Product Change Notification

1. ECR #: 164364
Notification #: 333

3. Series:
• SSM - .025 SOCKET STRIPS

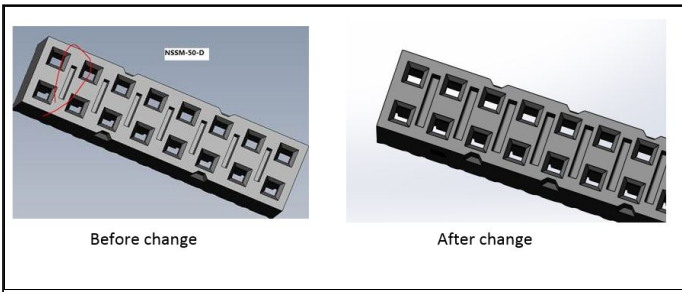
5. Description of Change:
Void Coring features were updated to the top side of the body for improved flatness.

The change in void coring can be visually identified, without magnification, by viewing the top side of the part.

7. Reason for Change:
Void coring was modified in order to improve the flatness of the body during the molding process.

8. Impact of Change on Form, Fit, or Function:
• Form - this is a visual change only. There are no performance differences with this product change.
